R.E. Ginna Nuclear Power Plant
Renewed Facility Operating License No. DPR-18
NRC Docket Nos. 50-244 and 72-67

Subject: License Amendment Request for Approval of Changes to Emergency Plan Staffing Requirements

Subject: License Amendment Request for Approval of Changes to Emergency Plan Staffing Requirements

Figure B-1a: Exelon Overall ERO Command Structure

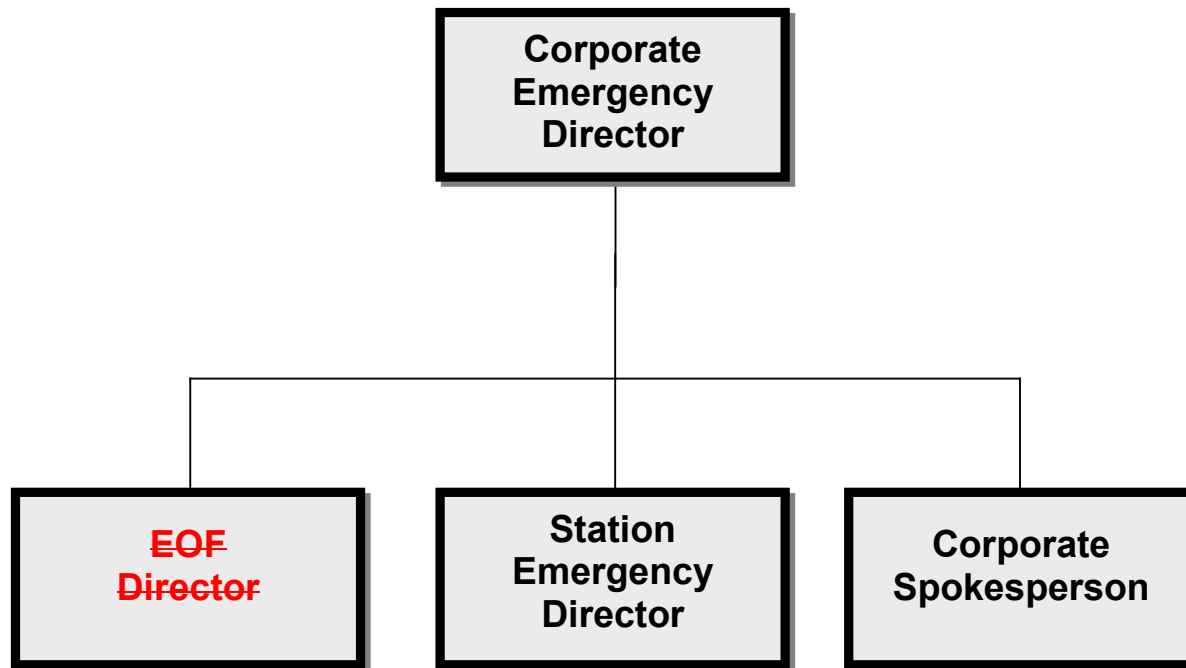
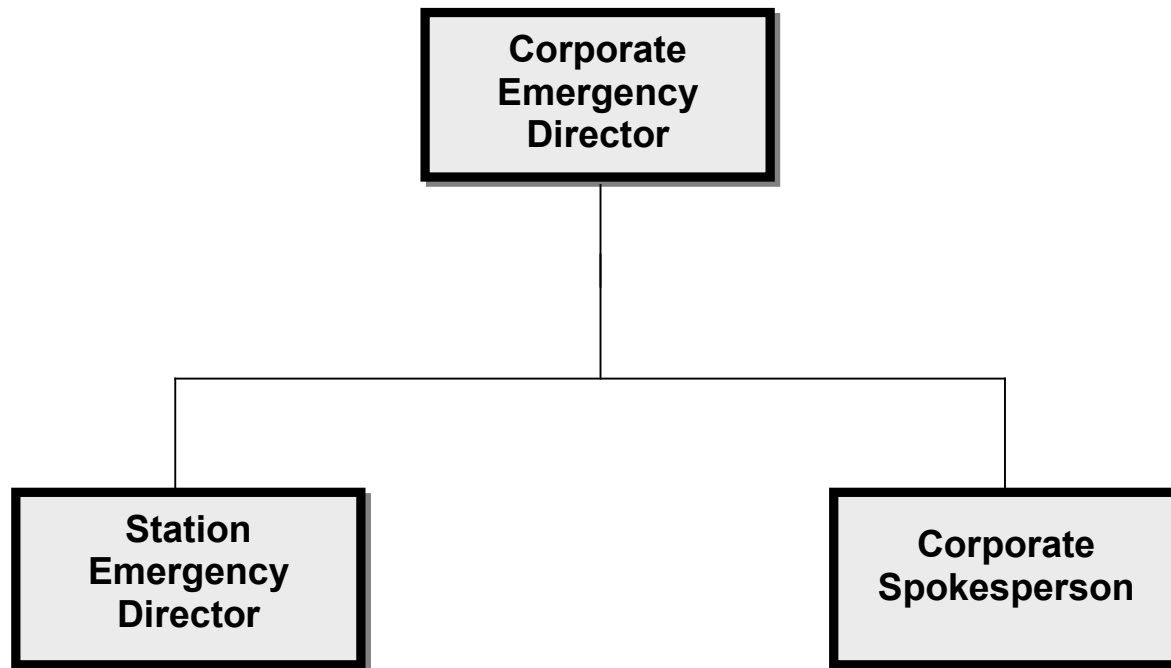
ERO staffing tables contained ~~within the station specific Annexin Appendix 5~~, lists the key positions of the ERO ~~and the supporting positions assigned to interface with federal, state, and county authorities~~. Figures B-1a through B-1d illustrates the overall emergency response organization. Section B.5 discusses specific responsibilities and the interrelationships for key positions.

ERO staffing tables contained in **Appendix 5**, lists the key positions of the ERO. Figures B-1a through B-1d illustrates the overall emergency response organization. Section B.5 discusses specific responsibilities and the interrelationships for key positions.

Figure B-1b: Emergency Onsite Organization

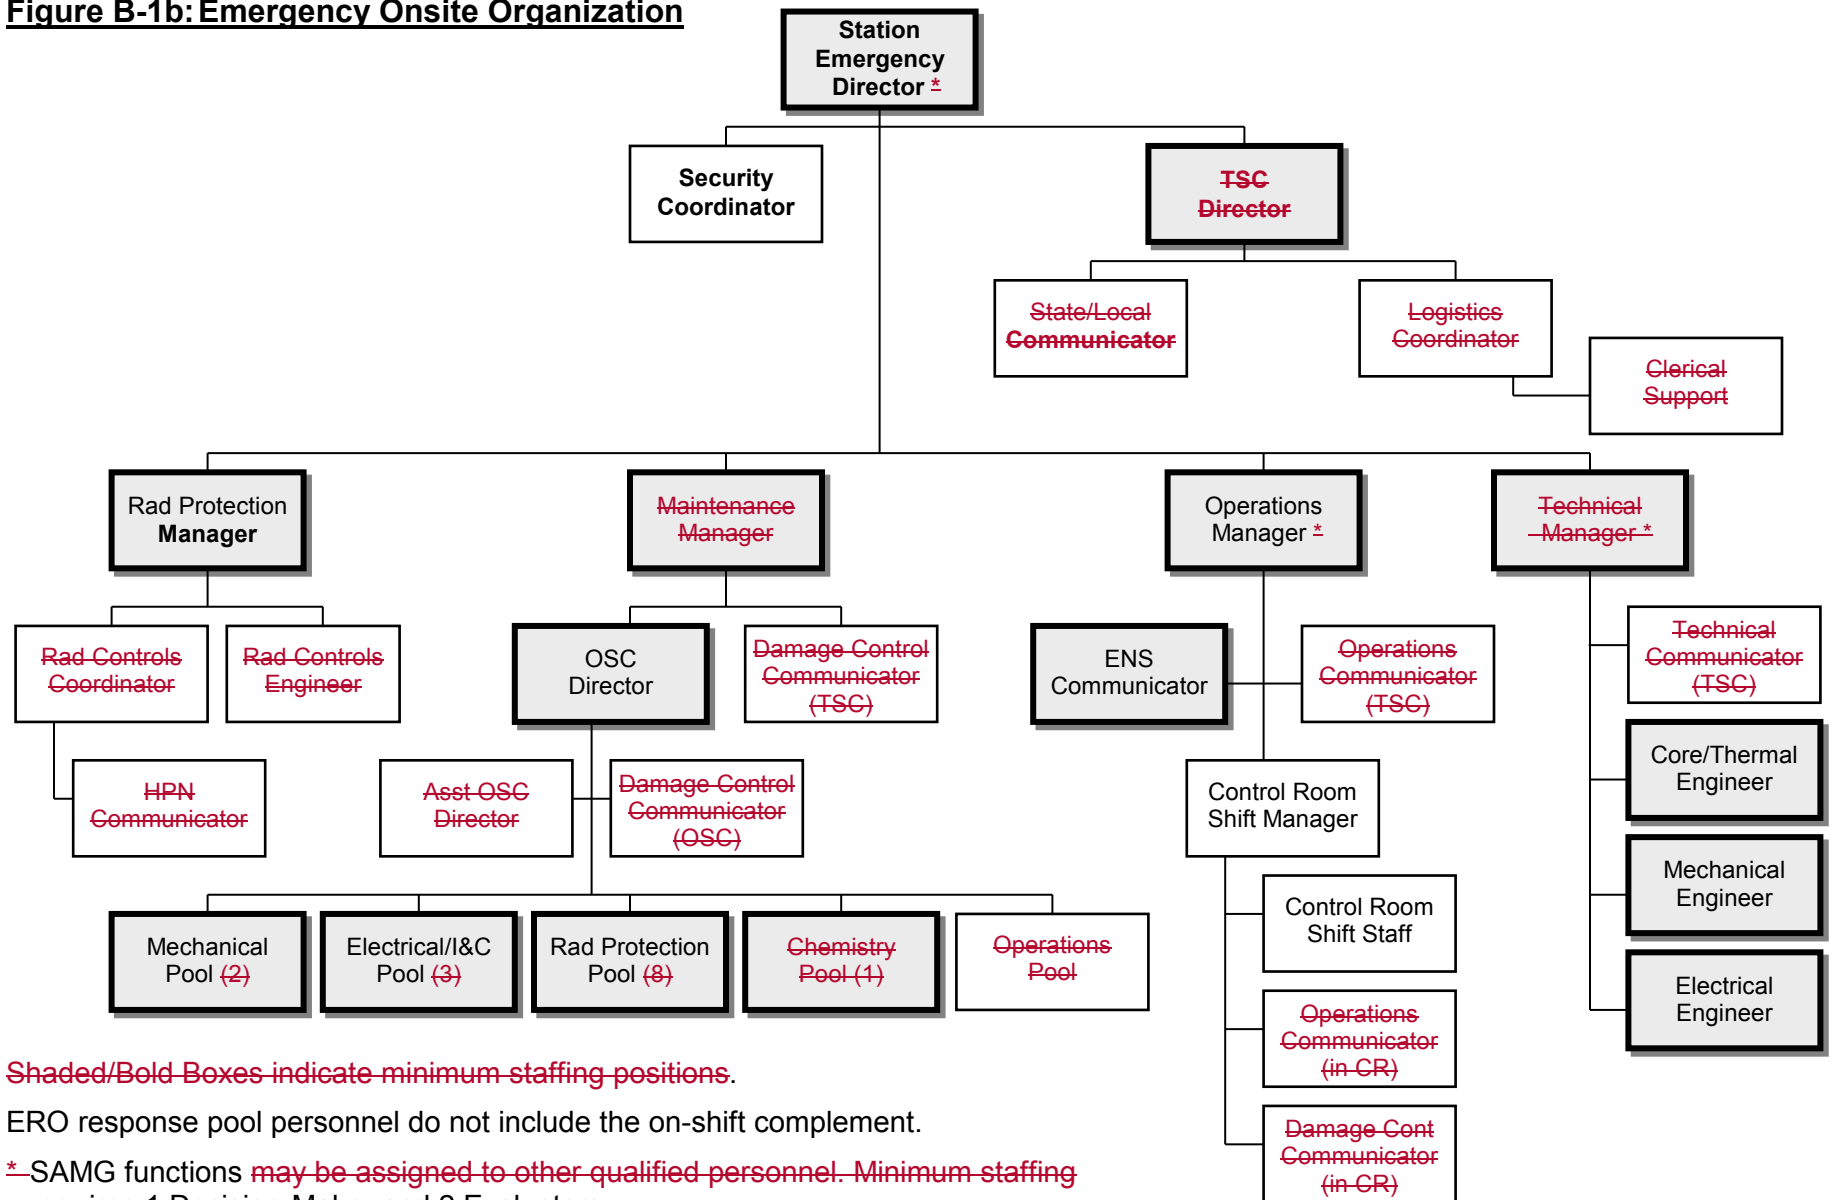
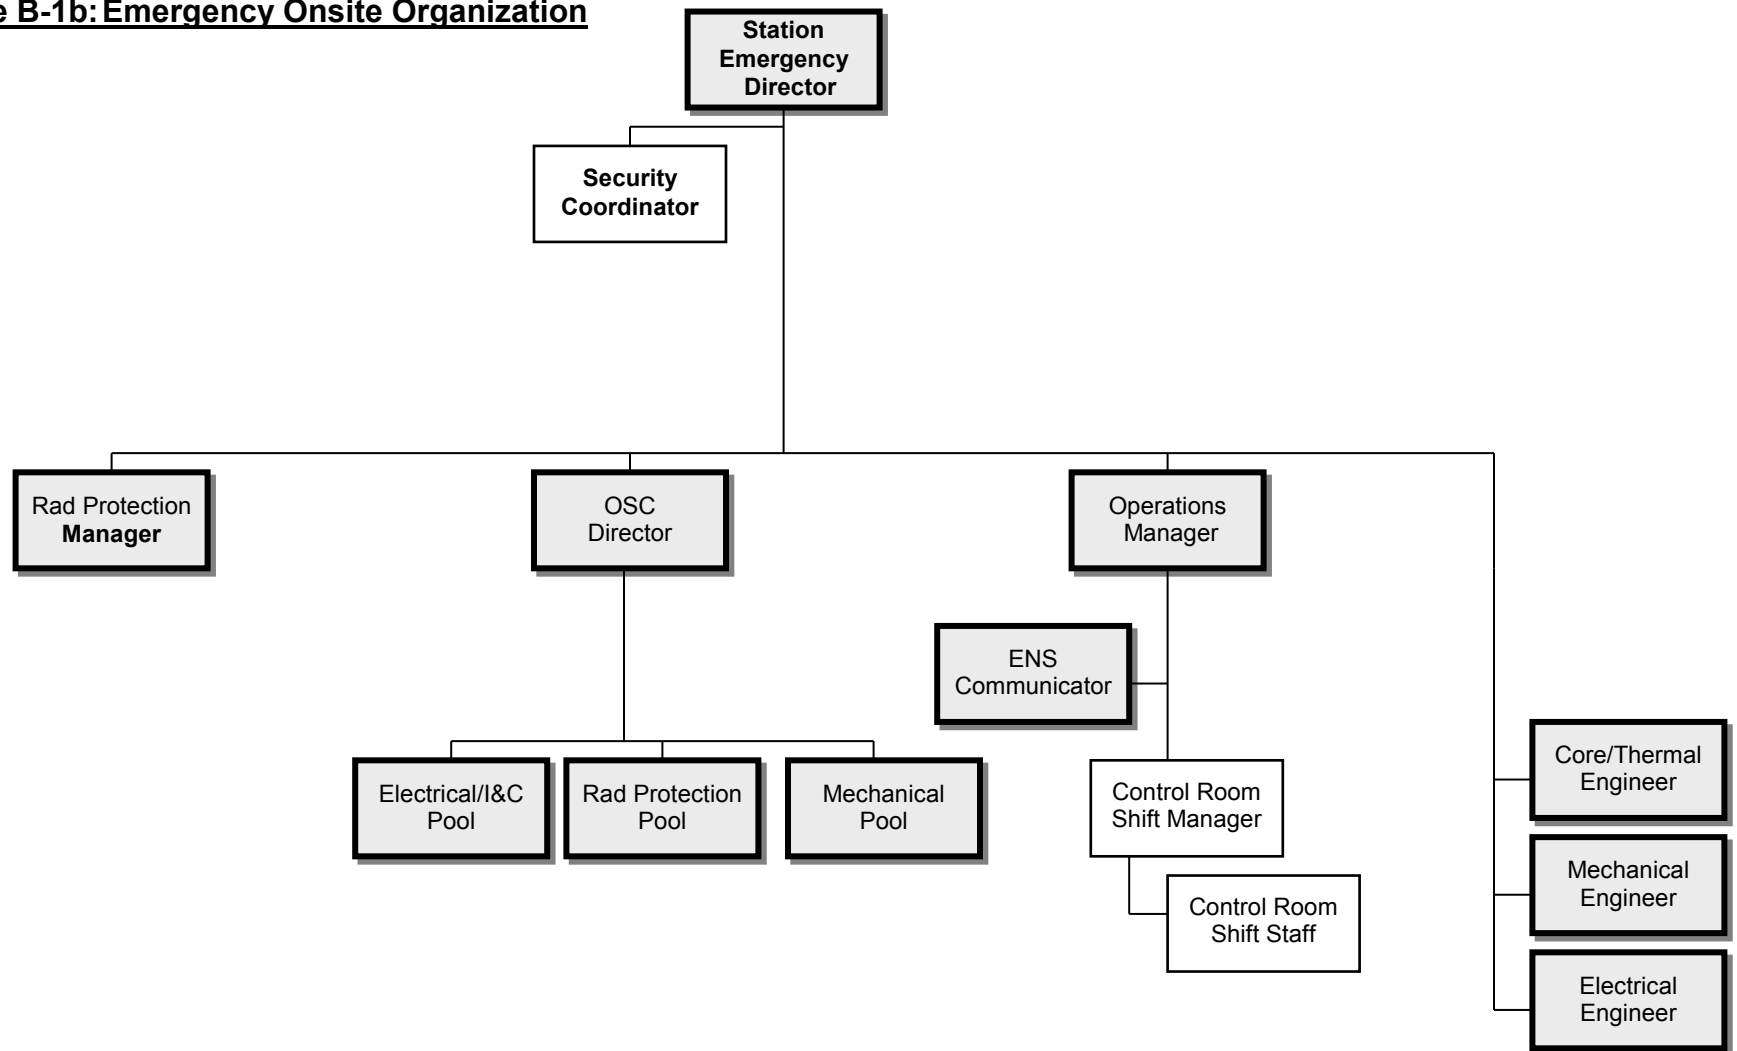
*-SAMG functions may be assigned to other qualified personnel. Minimum staffing requires 1 Decision-Maker and 2 Evaluators.

SAMG functions requires 1 Decision-Maker and 2 Evaluators.

Figure F-1: Exelon Notification Scheme (For Full Augmentation)

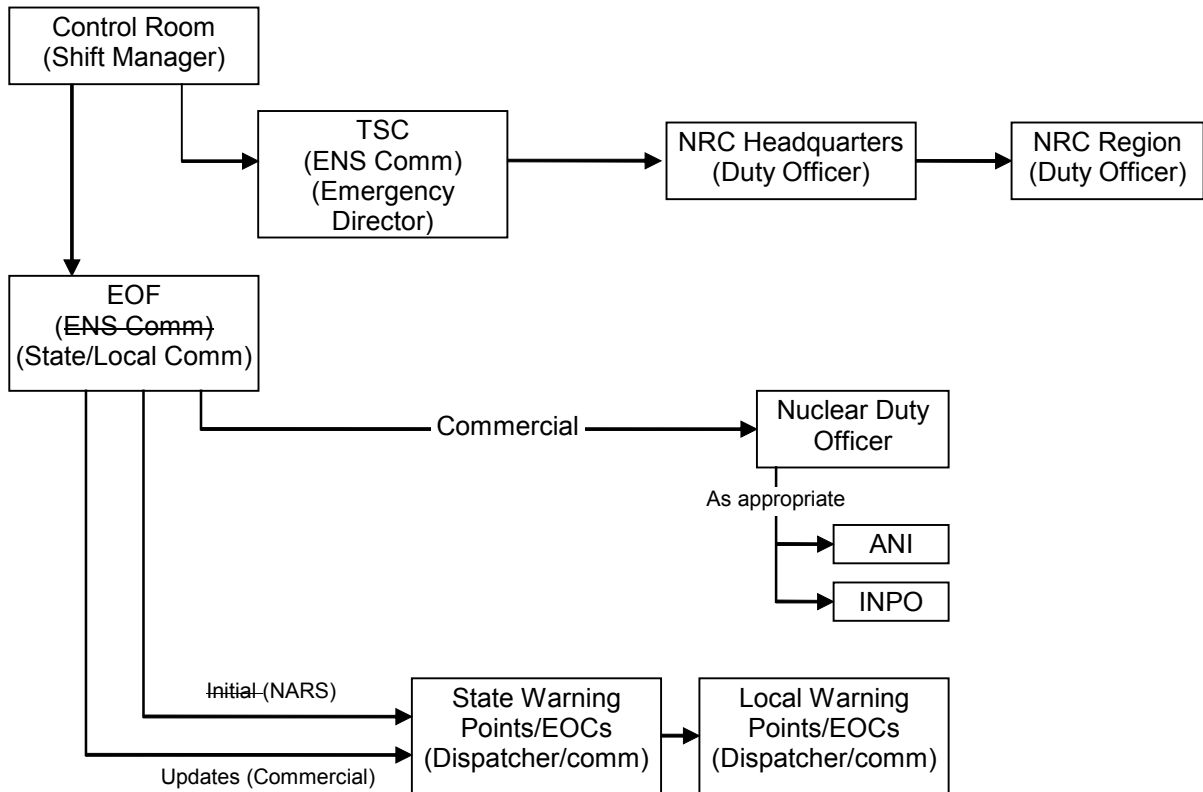
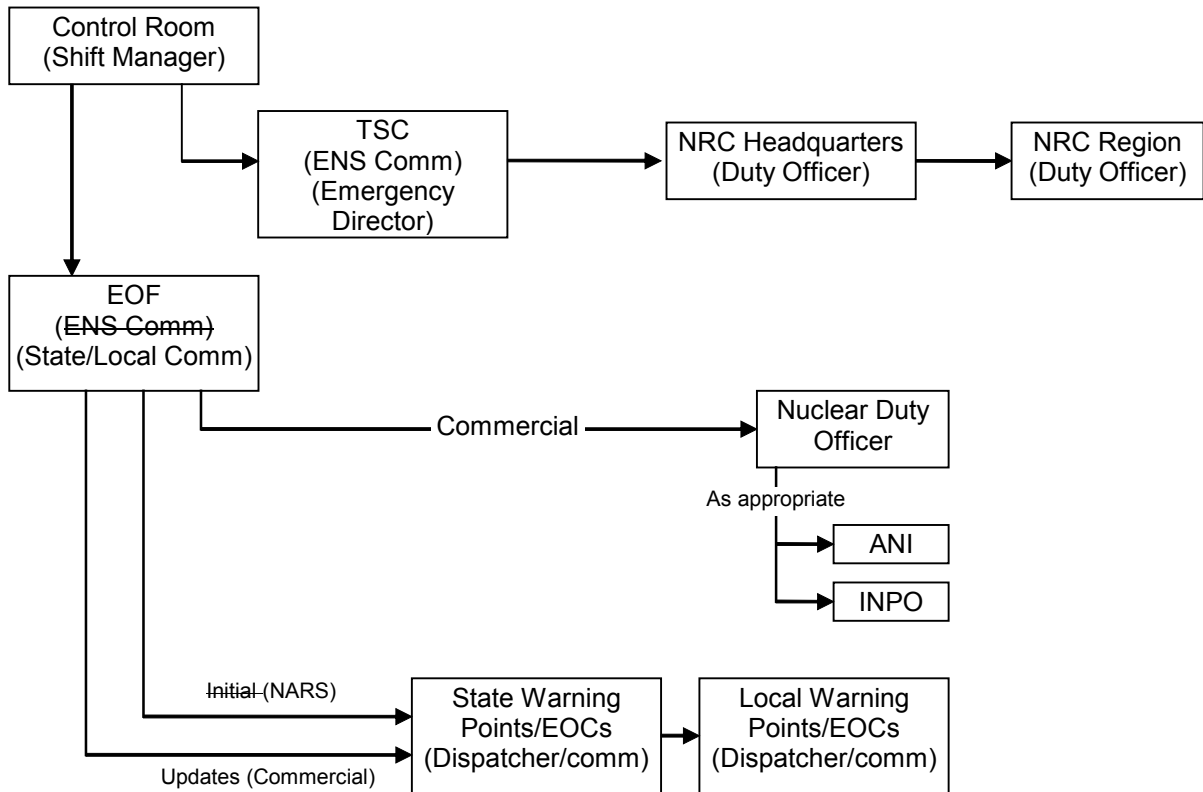
~~Health Physics Network (HPN): There also exists a separate dedicated telephone between the NRC, the TSC, and EOF for conveying health physics information to the NRC as requested or as an open line.~~

Figure F-3: NRC Communications for Nuclear Response

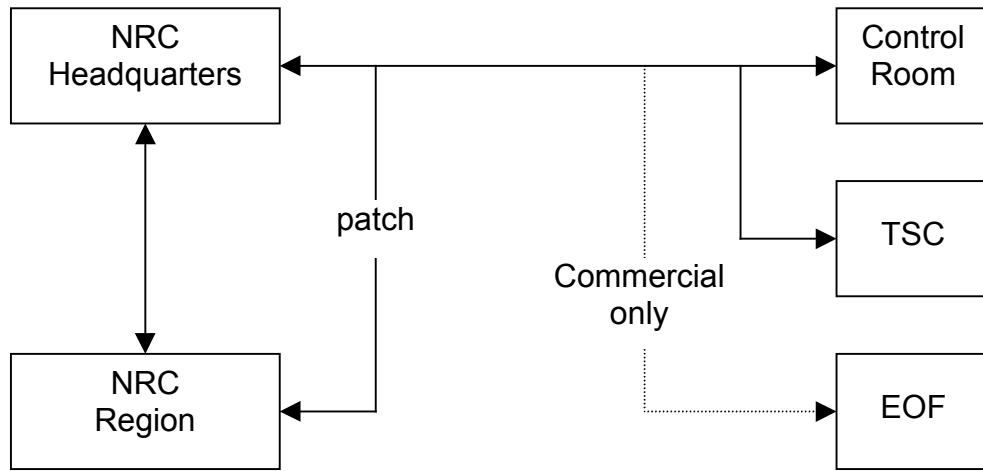
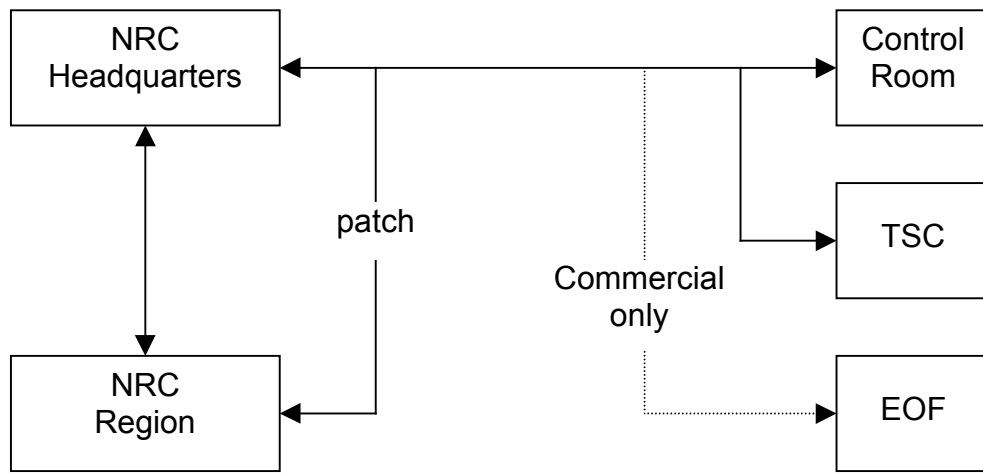
NOTE: ENS ~~and HPN~~ circuits may use the Federally maintained system, company tie lines or PBX as dedicated primary communications systems and have commercial backups.

NOTE: ENS circuits may use the Federally maintained system, company tie lines or PBX as dedicated primary communications systems and have commercial backups.

Figure 2.1 Shift ERO

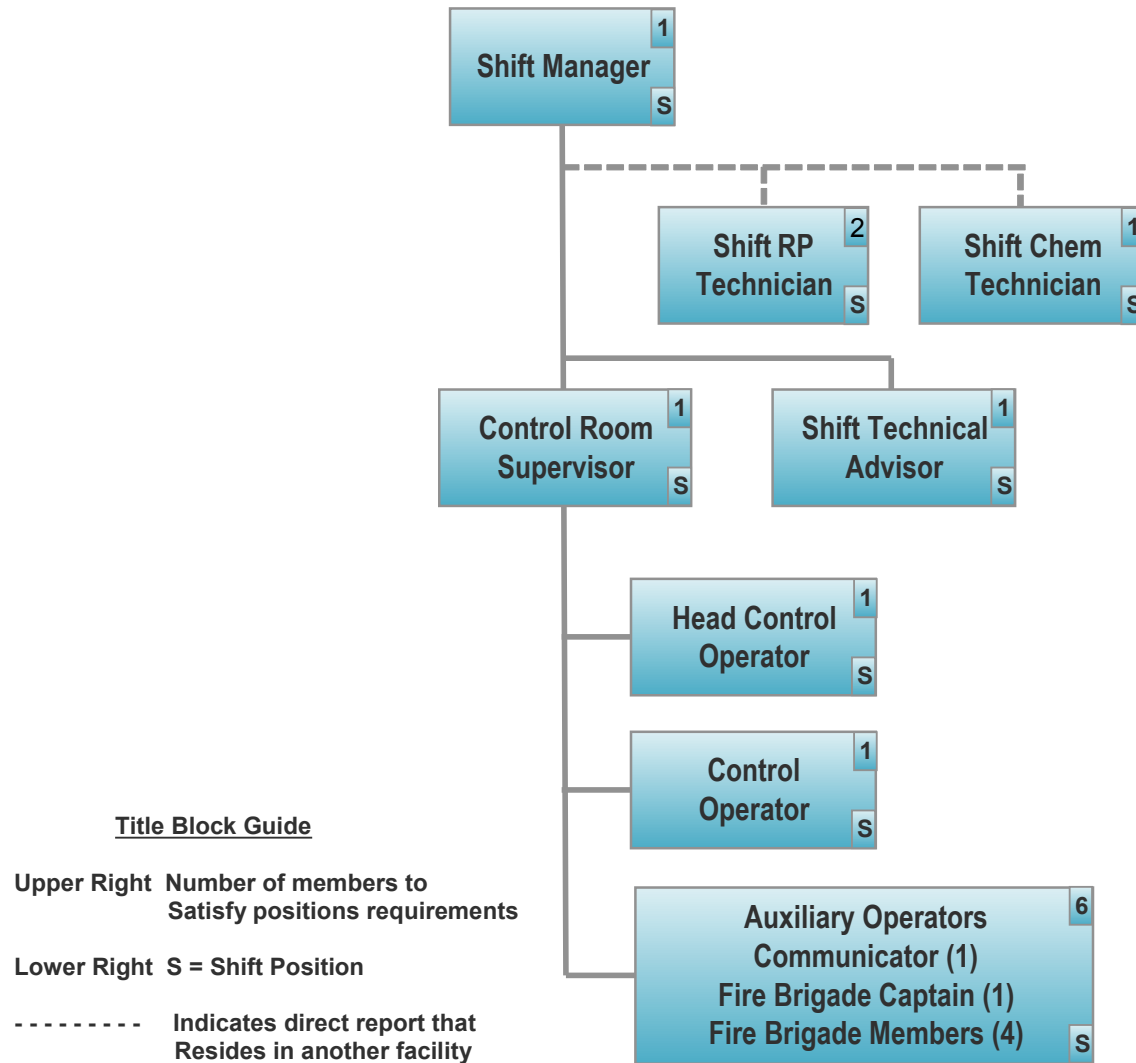
2.1.1 The content and format of the Ginna Emergency Plan Annex EP-AA-1012, Figure 2-1, "*Minimum On-Site Staffing Requirements*," will be revised to align with the NRC's Alternative Guidance. This includes revisions to the EP Functions and Major Tasks, as well as the Minimum Staff assigned to these areas. The proposed changes will result in a change in some designated Minimum Staff responders and the relocation of the Full Augmentation staff from the Emergency Plan to Ginna EPIPs, consistent with the NRC's Alternative Guidance.

Ginna will maintain two (2) qualified RP staff members on-shift for this function. The proposed revision removes the Chemistry reference from Figure 2-1. The Chemistry/Radiochemistry function listed in Table B-1 to Revision 1 of NUREG-0654, is no longer needed as the need for immediate reactor coolant sampling has been reduced due to the variety of available plant indications of fuel damage available at Ginna. Early indications of fuel damage can be identified through Containment Radiation Monitors, Core Instrumentation, or Effluent Radiation Monitors, all of which are available in the MCR.

The proposed revision also removes the one (1) Minimum Staff Chemistry personnel from Figure 2-1. The Chemistry/Radiochemistry function listed in Table B-1 to Revision 1 of NUREG-0654, is no longer needed as the need for immediate reactor coolant sampling has been reduced due to the variety of available plant indications of fuel damage available at Ginna. Early indications of fuel damage can be identified through Containment Radiation Monitors, Core Instrumentation, or Effluent Radiation Monitors, all of which are available in the MCR. If reactor sampling is desired, Chemistry Technicians are on staff at Ginna and would be called in as necessary to support the event.

The proposed revision also removes the one (1) Minimum Staff Chemistry Lead from Figure 2-1. The Chemistry/Radiochemistry function listed in Table B-1 to Revision 1 of NUREG-0654, is no longer needed as the need for immediate reactor coolant sampling has been reduced due to the variety of available plant indications of fuel damage available at Ginna. Early indications of fuel damage can be identified through Containment Radiation Monitors, Core Instrumentation, or Effluent Radiation Monitors, all of which are available in the MCR. If reactor sampling is desired, Chemistry Lead Technicians are on staff at Ginna and would be called in as necessary to support the event.
